## NOTICE OF PUBLIC MEETING PLANNING COMMISSION

Planning Commission  
September 11, 2025 @ 5:30 PM

- 1. Preliminary Plat Review for the CW Santa Clara Commercial Subdivision located on the northwest corner of Pioneer Parkway and Red Mountain Drive. McKenna Christensen, Cole West LLC, applicant.
  - 2. Preliminary Plat Review for the CW Santa Clara Residential Subdivision located north of Pioneer Parkway and west of Red Mountain Drive. McKenna Christensen, Cole West LLC, applicant.
  - 3. Preliminary Plat Review for the Solace Townhome Subdivision located on the corner of Rachel Drive and Affirmation Drive. Dustin Garr, New Wave Construction, applicant.

Staff Report

**PHASING  
PLAN**

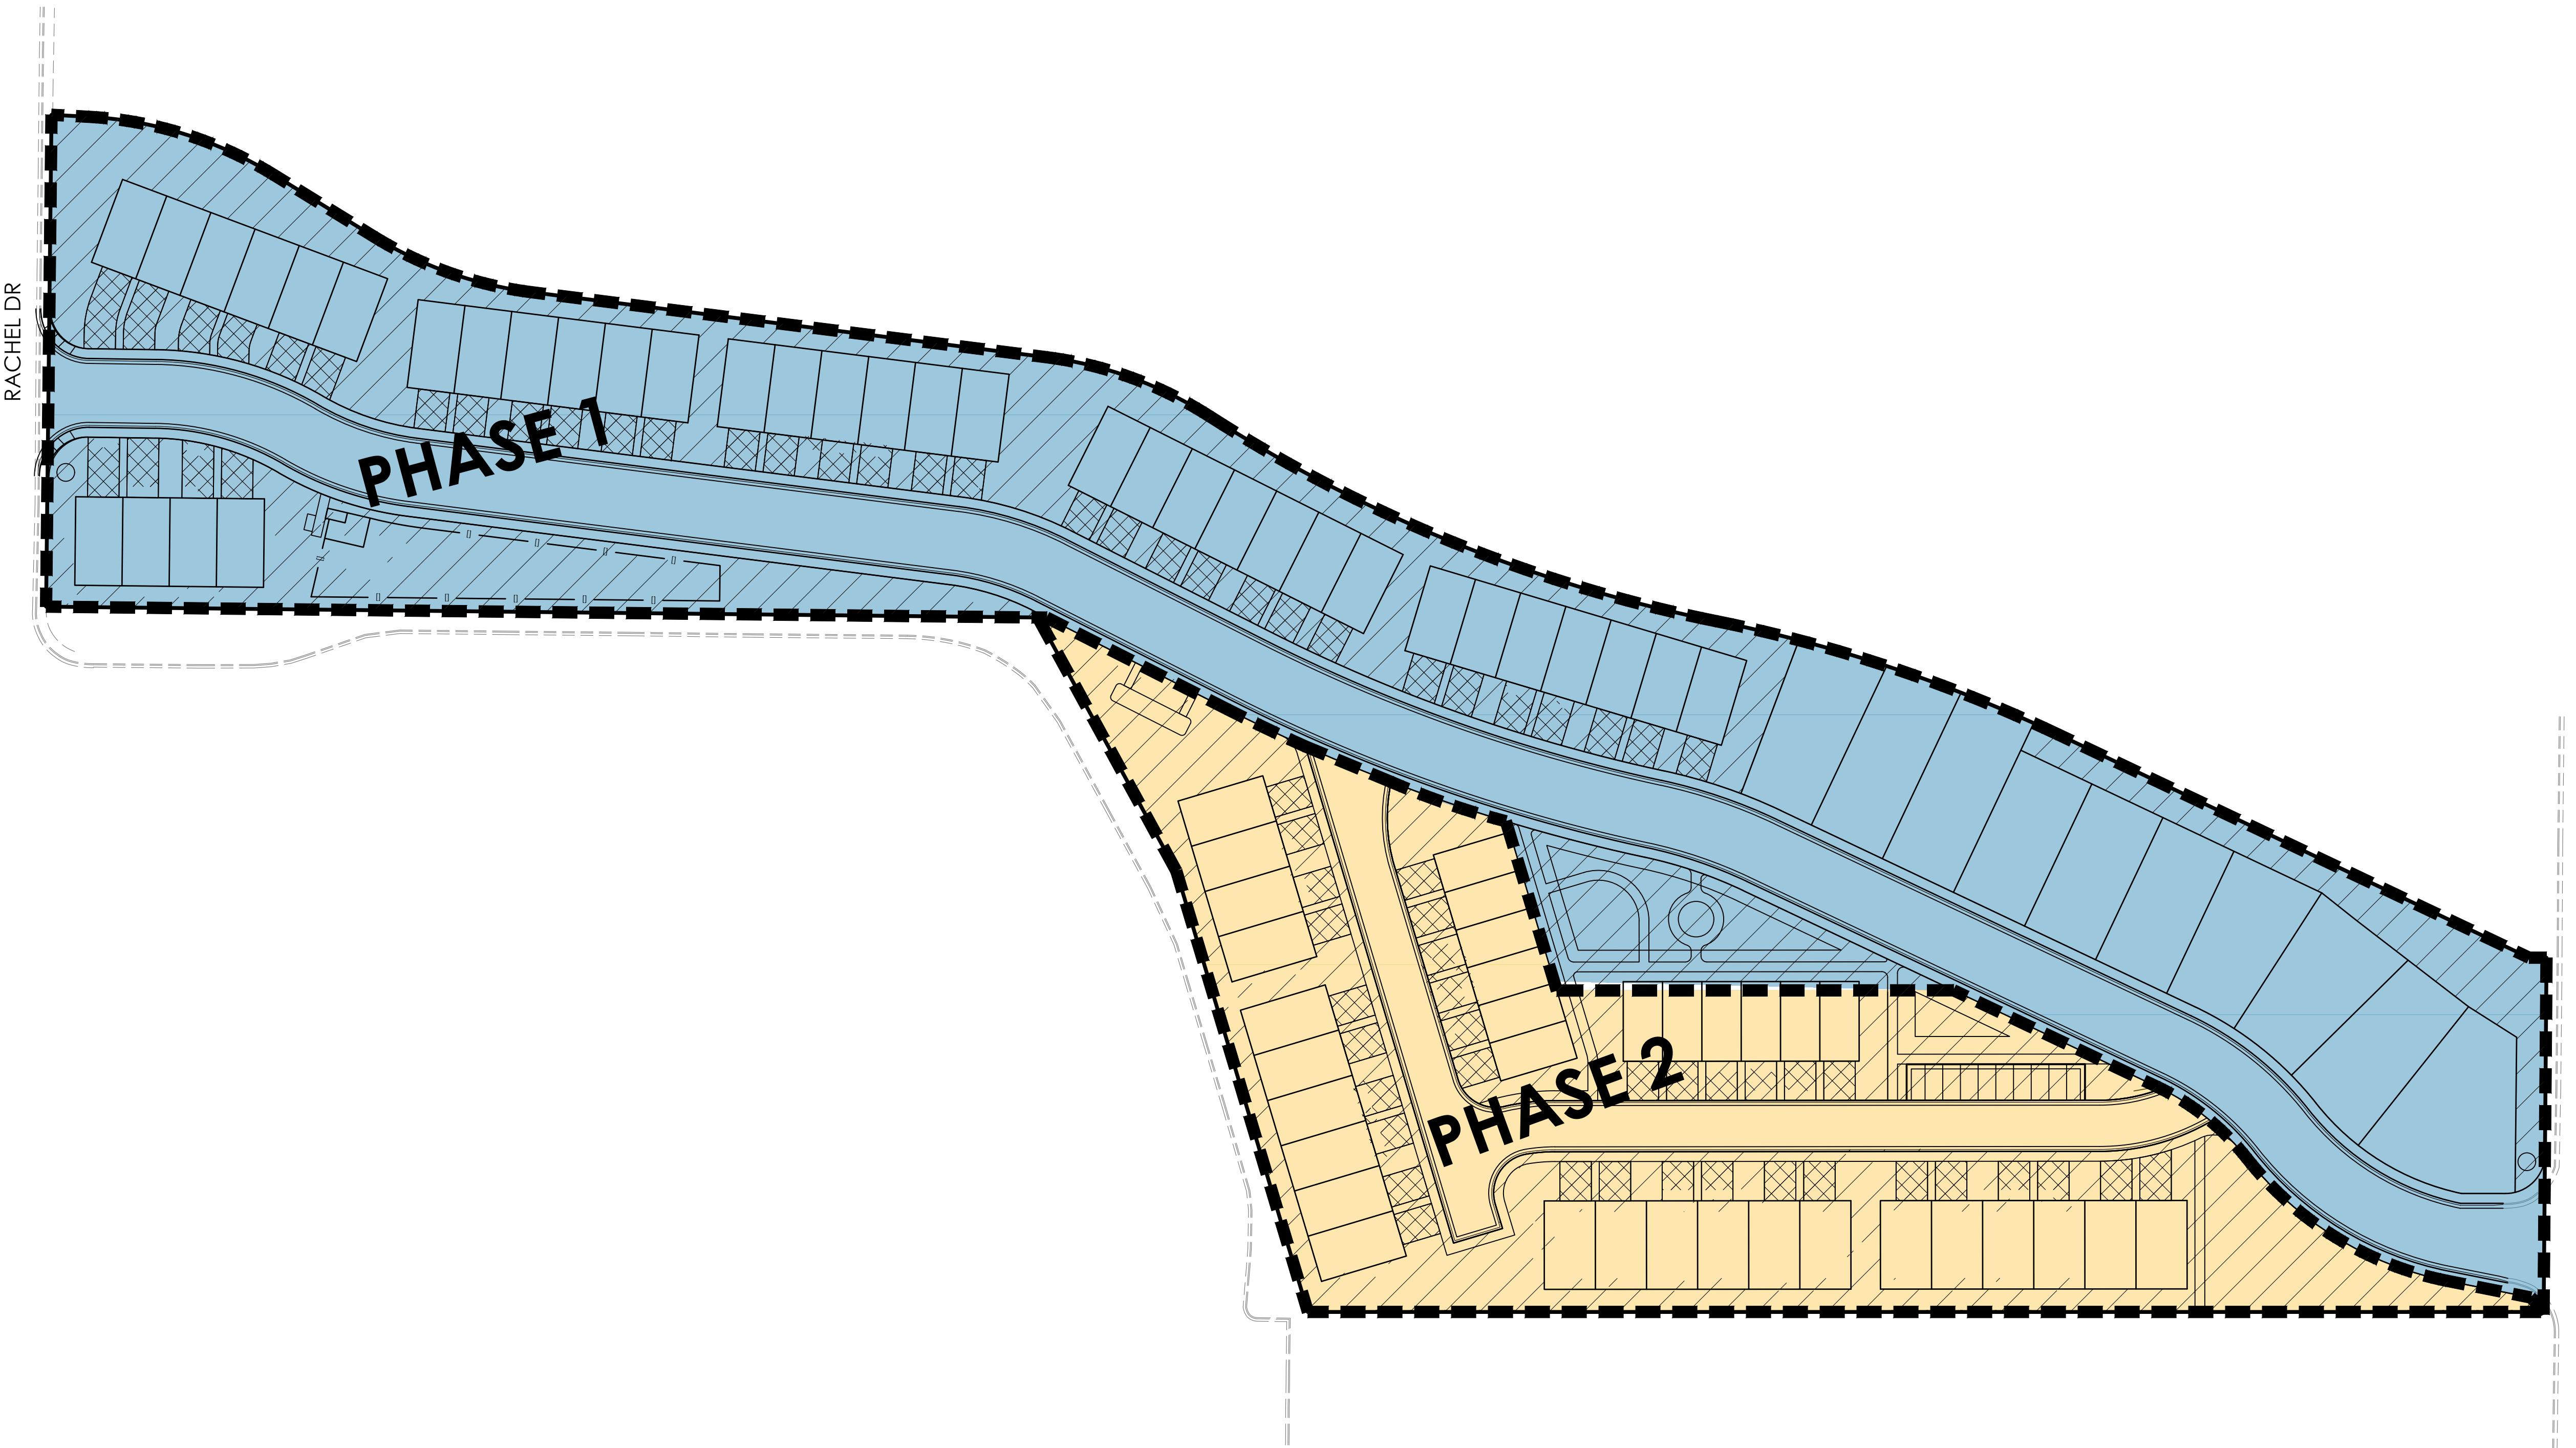
1. **Residential Unit Count:** The Preliminary Plat includes a total of **eighty (80) residential units**. This includes 58 two-story front-loaded townhome units, 12 three-story rear-loaded units, and 10 small single-family lots. The subject property is 7.35 acres in size. This equates to a project density of 10.9 units/acre. The Phasing Plan indicates that two (2) project phases are proposed and includes the amenities for each phase of the project. **A copy of both plans is attached.**

3. That a Project Phasing Plan be followed for the overall project.
4. That the building design/materials/colors/height/and setbacks comply with the information in the staff report as presented by the applicant. That substantial changes to these items require an amendment to the Subdivision Plat.

## Fencing & Entry Monuments

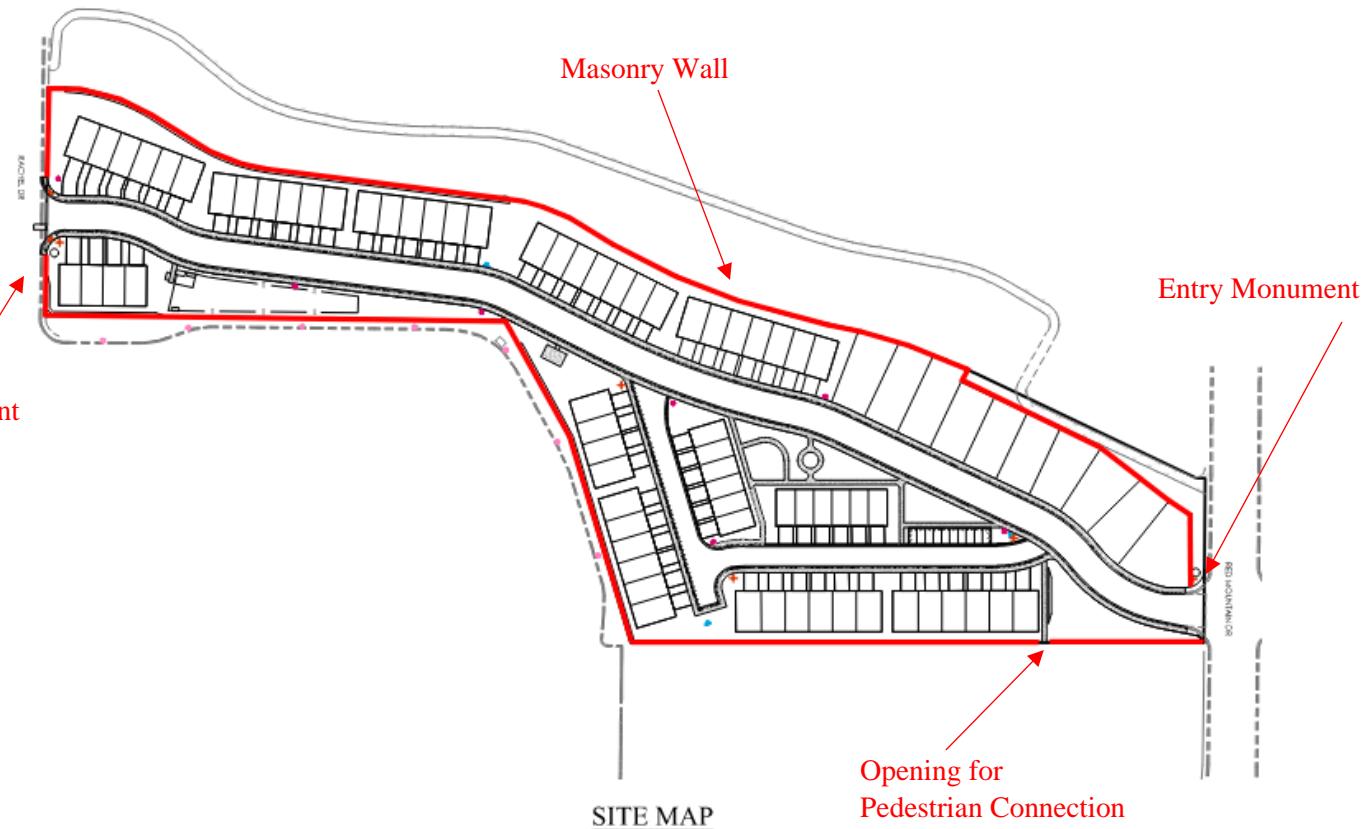
11. **Fencing:** Project fencing is proposed for the project. This will **include a 6' CMU masonry wall** around the perimeter of the residential area and adjacent to the commercial area. The applicant will need to work with City staff to coordinate fencing height, location, and site visibility at the two project access points (Rachel Drive & Red Mountain Drive) the commercial and residential projects. A **Fencing Plan** is attached.

# PHASING PLAN

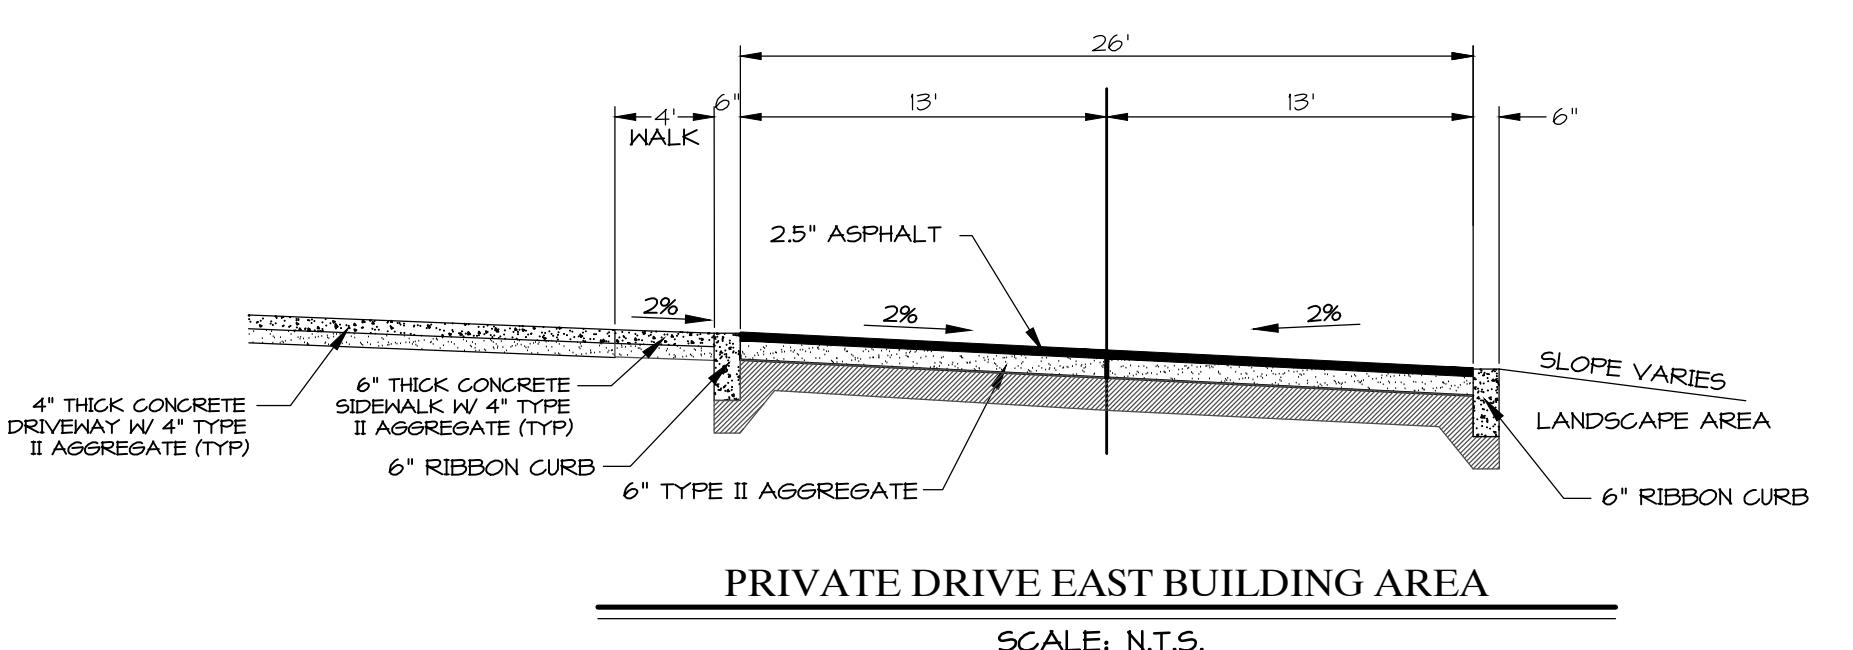
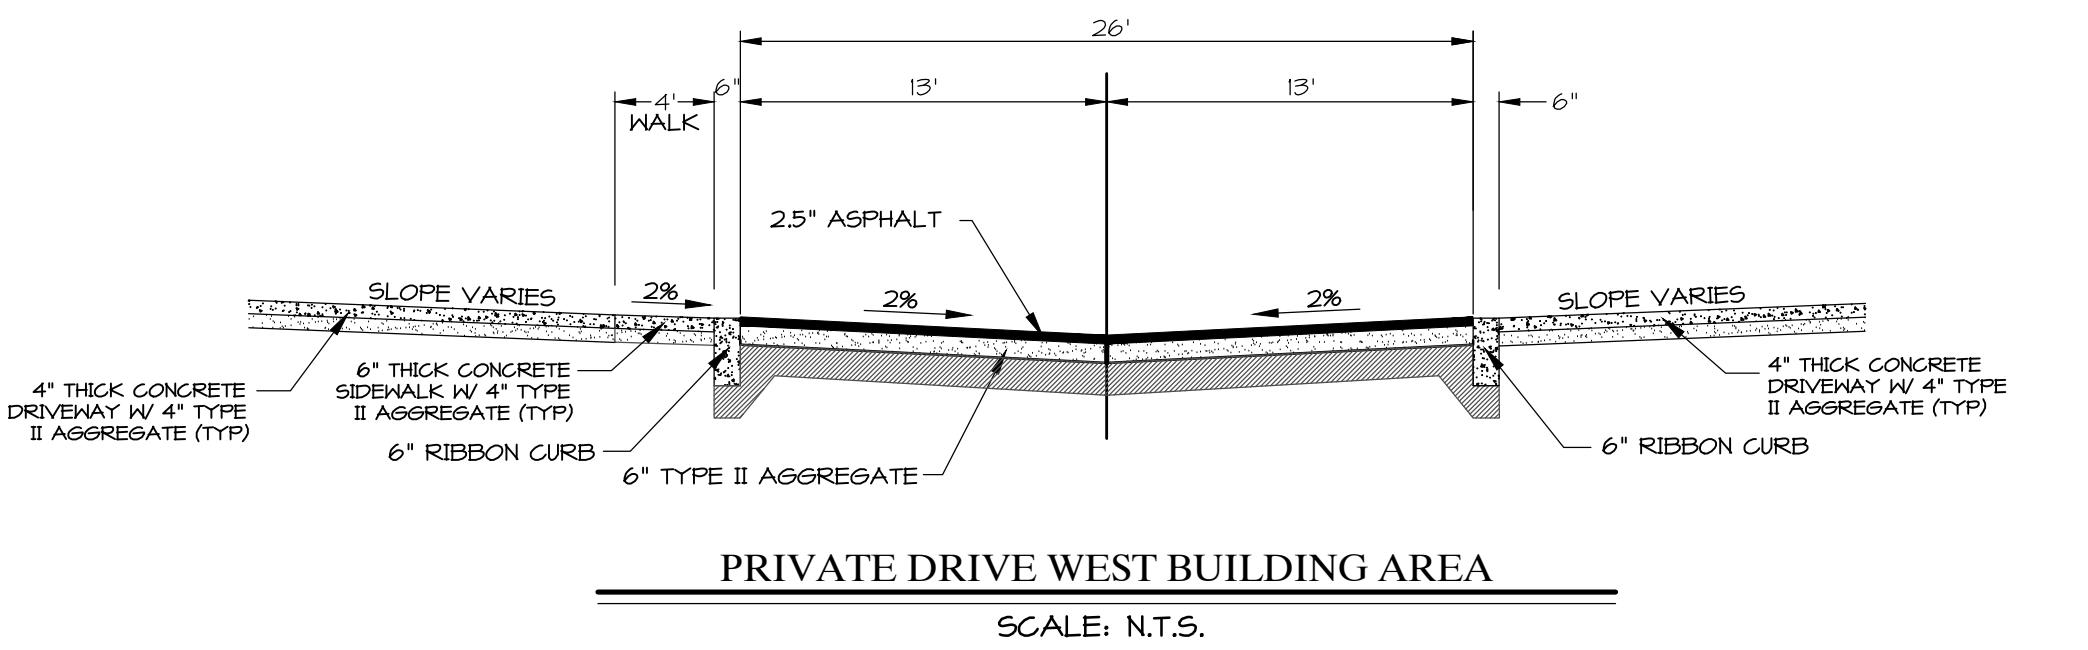
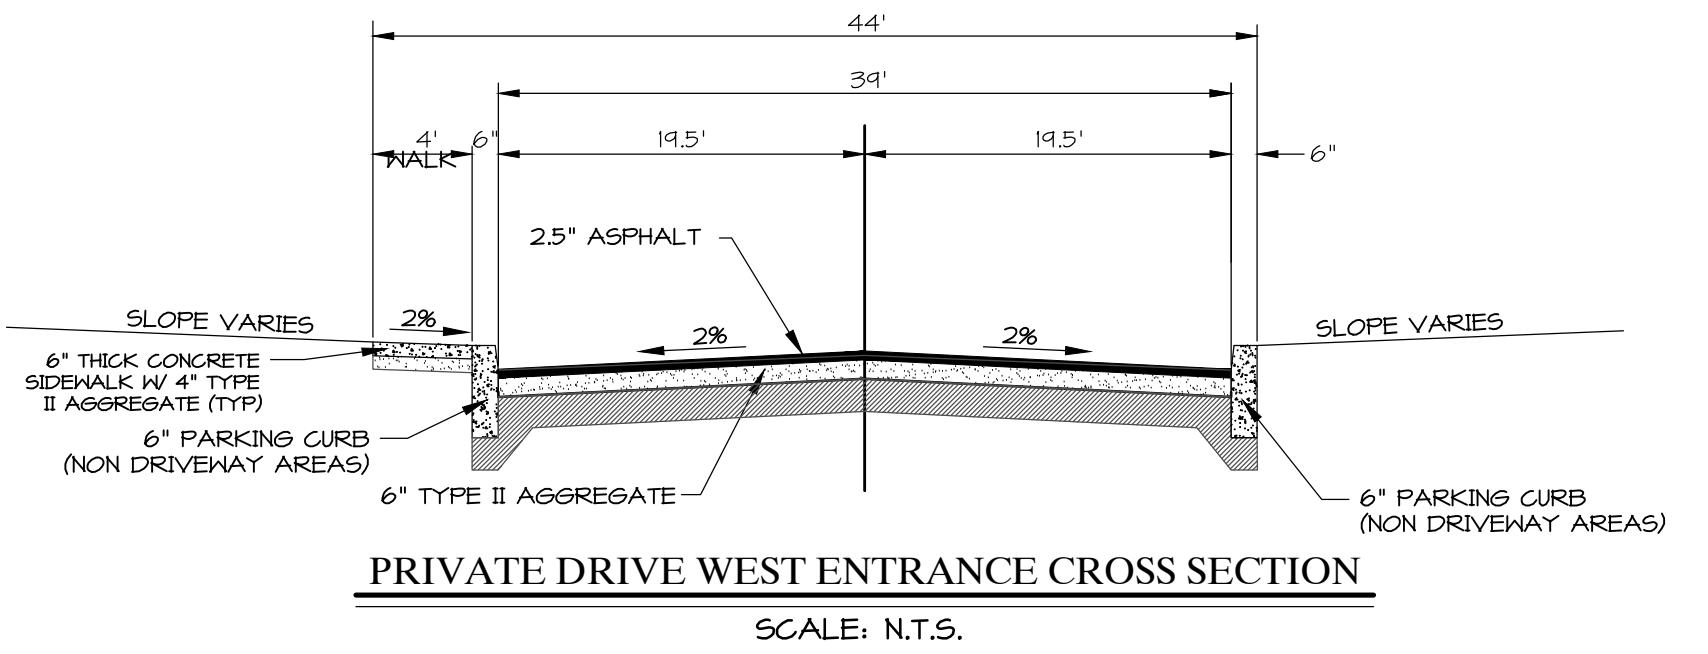
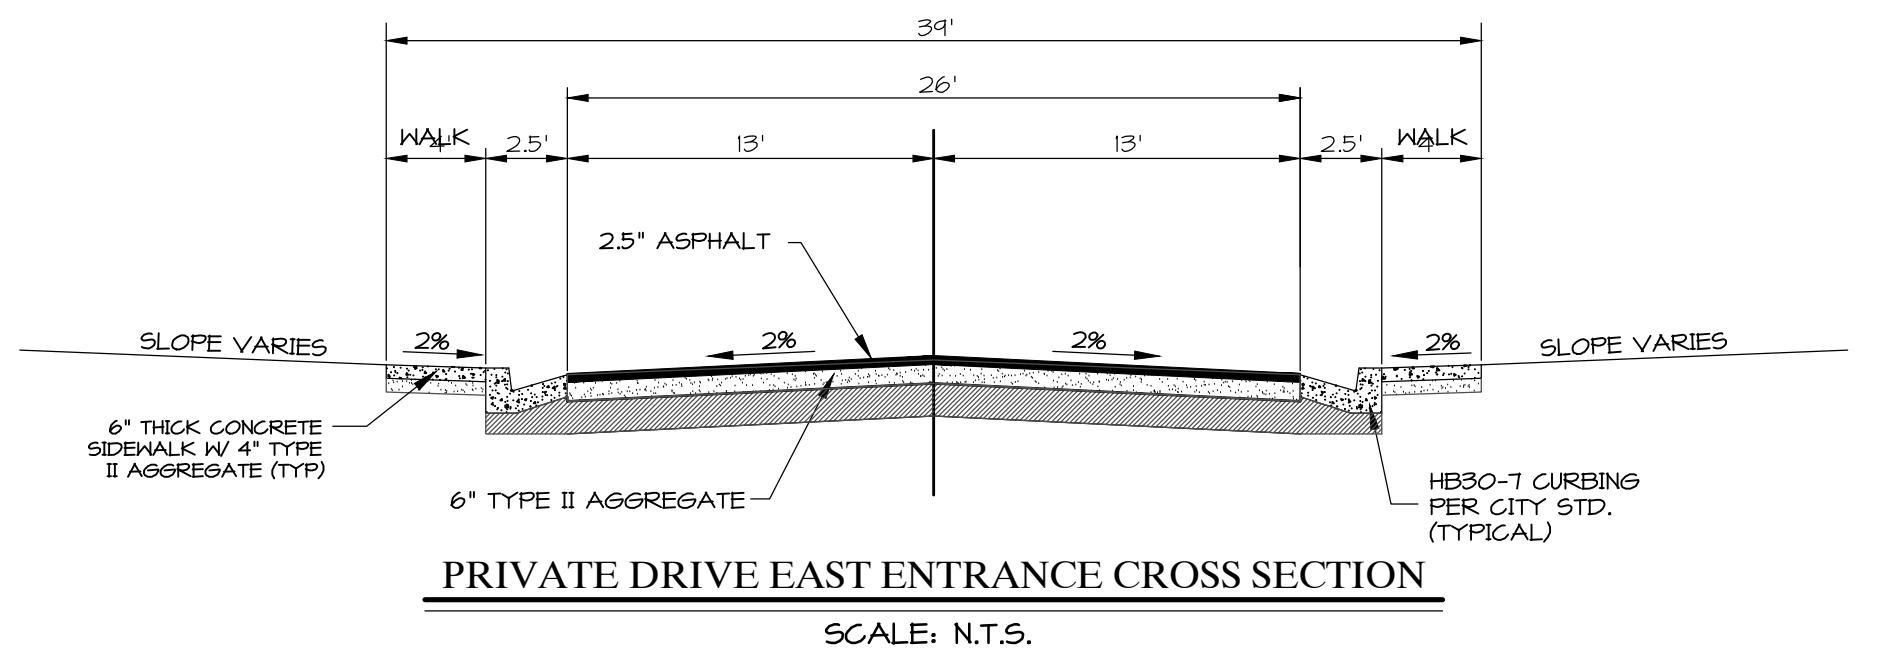
1. **Residential Unit Count:** The Preliminary Plat includes a total of fifty-six (56) townhome units on 8.16 acres. This equates to a density of 7.2 units/acre. The **units will be located within eight (8) 7-Plex buildings.** Phase 1 will include three (3) buildings located within the western half of the project, with Phase 2 including five (5) buildings within the eastern half of the project. A copy of the Preliminary Plat and Phasing Plan has been included. The Phasing Plan also includes project amenities included with each project phase. **A copy of both plans is attached.**

4. **Public trail Access:** **A 10' multi-use trail is required** through the center of the project adjacent and parallel to the Tuacahn Wash (see Preliminary Plat & Phasing Plan). This trail is required as per the **2018 Trails Master Plan.** This section of trail will tie in with the Solace Subdivision Phase 1 to the north, and the Desert Village Townhomes to the south.

7. That the required 10' public multi-use trail (2018 Trails Master Plan) be put in place as per the Phasing Plan and included on the final plat.
8. That the applicant is required to comply with City Ordinance #2024-02, Water Efficient Landscaping & Conservation Standards. That a secondary water connection is required for outdoor water use.
